Technical Notes

Analysis of the Results of the Network Seismic Risk and Vulnerability Functions Evaluation Performed by the Costa Rican Institute of Aqueducts and Sewers

Figure 18 Vulnerability functions for seated unanchored metal tanks proposed by AyA (blue), and for this report (red)

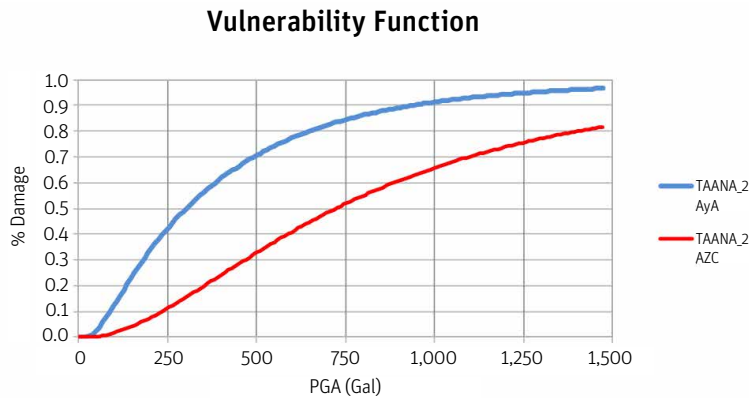
It should be noted that there are very few references to RD values which have widespread acceptance among professional engineering circles. In addition to this, the definition of damage provided by HAZUS does not offer many objective technical data to relate loss to, say, return periods or some other measure of recurrence. Given this, it is clear that determining RD values for each condition of damage will always be a subjective exercise associated with high uncertainties. Despite this, in the table of values above, a value of RD 0.2 (20%) for a condition of minor damage may, at first, be considered to be very high.

Let us consider this particular case. In a condition of damage graded as “minor,” a relative loss of 20% in a tank means that a fifth of the value of the tank is lost or unusable, but that it has not lost any content or functionality. This combination of conditions does not seem to be consistent, as a much smaller relative value of damage was expected. To illustrate this, a relative damage value equal to 2% will be proposed for minor damage. All other conditions of damage can be analyzed in this way (Table 3).

The blue curve is the one originally used by AyA, while the red curve plots the relative damage values proposed for this report. This modification generates a curve which, in general, uses lower relative damage values than the original, although the steepness of the curve is maintained in some sectors, which means that the fault mode shares the same essential behavior. It can be seen that when the intensity of the event is small (say less than 490 Gal), the values of the modified curve are significantly lower than those of the original, and, in particular, when the values are less than 250 Gal in intensity, this difference may be considerable. Since the ALE is a weighted calculation of losses that can be caused by all events, considering their annual occurrence frequency, then it is very likely that these small but very frequent events will have an important influence on the final risk premium estimate, which explains the very high value of losses in the estimates of the AyA, which are unrelated to the actual condition of these tanks.

Condition of Damage	RD (AyA)	RD (AZC/illustrative proposal)
Minor damage	20%	2%
Moderate damage	40%	15%
Extensive damage	80%	50%
Complete damage	100%	100%

To confirm this, we proceeded to make an assessment of all GAM tanks, using, for the Naranjal tank (inspected metal tank), a vulnerability function such as that shown in Figure 18. The ALE of this tank was found to be 8.65%, which is probably closer to the real condition of threat and vulnerability.

Figure 19 Vulnerability functions for seated unanchored reinforced concrete tanks proposed by AyA (blue), and for this report (red)

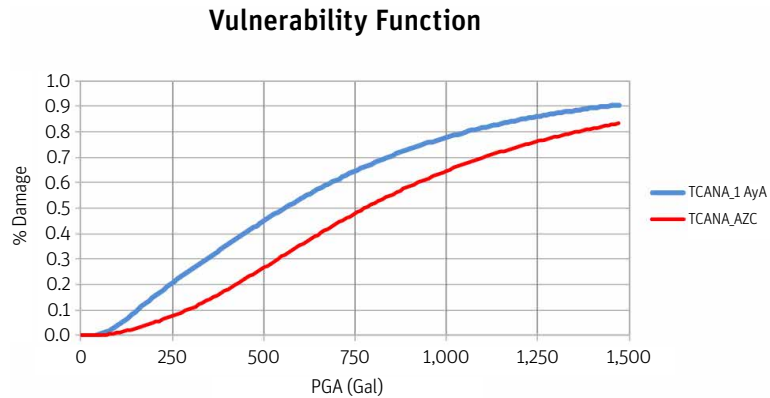
For the other tank inspected, a vulnerability function resulting in an ALE of 15.18% was originally used. To redefine the vulnerability function, the same RD values were used as those used in the case of the metal tank, which resulted in the vulnerability function shown in Figure 19.

As in the case above, there is a slight reduction in the relative loss values obtained with the new function with respect to the one originally employed by AyA. The use of this vulnerability function leads to an ALE of 5.93%.

Figure 20 Vulnerability function, where the abscissa corresponds to peak ground acceleration (PGA) (0–1,000 Gal) and the ordinates to the expected damage percentage

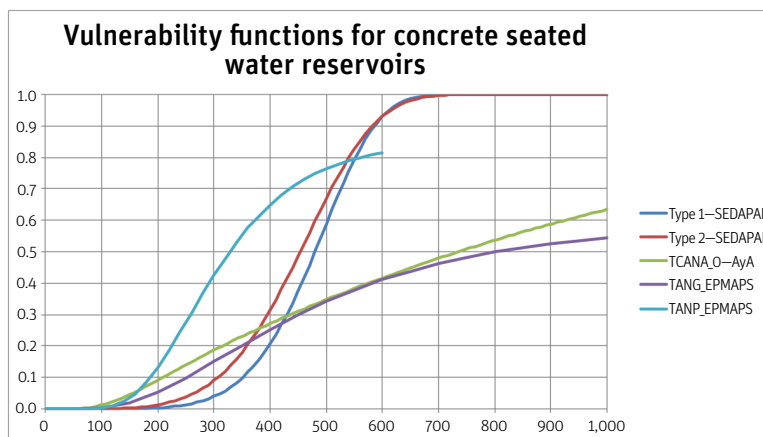
It can be seen that there is a great diversity of forms and loss values for the same intensity in the different curves. However, two types of curves can be distinguished: the ones of SEDAPAL on the one hand, and those of EPMAPS and AyA on the other. The vulnerability functions used in the SEDAPAL study are very different in terms of values from the curves in the EPMAPS and AyA studies, which is probably due to the various references used to determine these functions. SEDAPAL curves are characteristic of more fragile structural systems than those of AyA and EPMAPS, which means that in the SEDAPAL study it has been considered that the failure of a tank occurs relatively suddenly, without warning and within well-defined intensity limits, whereas AyA and EPMAPS curves suggest that the tanks will tend to fail gradually, slowly, showing the deterioration associated with the various levels of damage reached during successive load cycles.

Figure 21 Vulnerability functions, where the abscissa corresponds to peak ground acceleration (PGA) (0-300 Gal) and the ordinates to the expected damage percentage

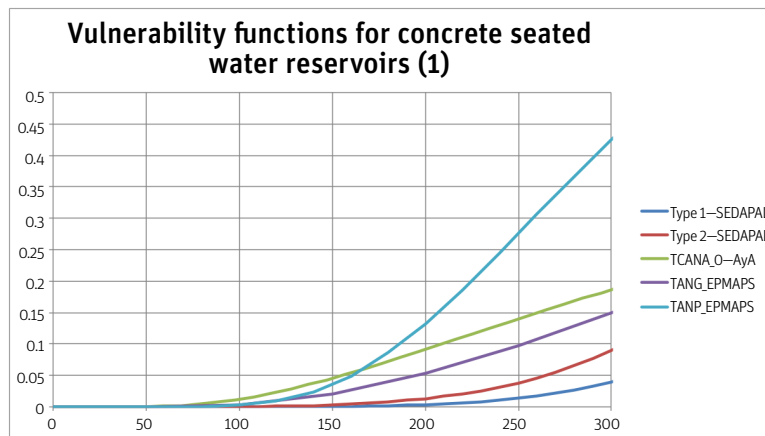
If the curves for levels of moderate or low intensity are examined in greater detail (Figure 21), this shows that the curve given by AyA generates higher values than the other curves (for the moment, we will leave aside the TANP-EPMAPS curve values). Concerning some of the curves, mainly TYPE 1–SEDAPAL, the loss values for the same intensity are significantly higher using the TCANA_O curve–AyA. Since it is very likely that the calculation of ALE will be strongly influenced by events in this range of intensities, it is to be expected that the AyA results will be greater than those obtained using the other vulnerability functions.

Figure 22 Vulnerability functions, where the abscissa corresponds to peak ground acceleration (PGA) (300-800 Gal) and the ordinates to the expected damage percentage

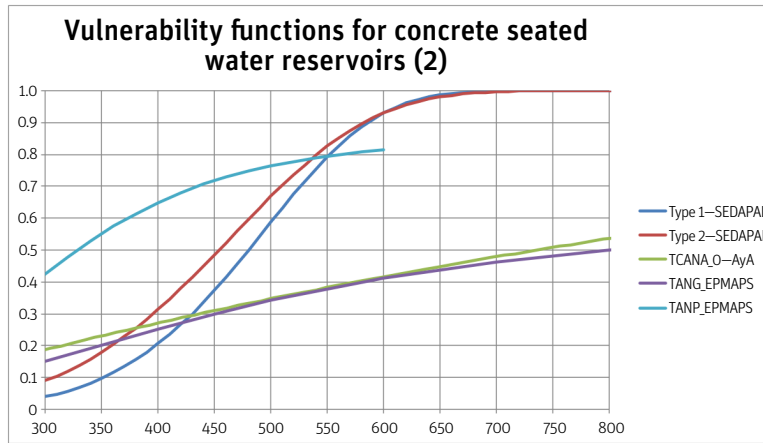
Now, let us look at the range of highest intensity (Figure 22). It can be seen that in a small initial interval, things remain the same as for low intensities, but suddenly the SEDAPAL curves increase their slope and significantly raise loss values, while the AyA and EPMAPS curves maintain an almost constant slope. Thus, for high intensities, the SEDAPAL vulnerability functions will produce much higher damage values than those of AyA and EPMAPS. This is relevant to the calculation of the ALE, where the interest is usually set on very high losses, associated with very rare events and therefore, very intense ones.

Accordingly, it can be concluded that for SEDAPAL, tanks are elements that work well at low intensities, but that when the intensity is increased slightly, widespread damage can occur violently, while for AyA and EPMAPS, the deterioration is gradual. It is of interest to establish which of the two approaches bears a greater relation with the true and actual behavior of concrete tanks when subjected to ground movements.
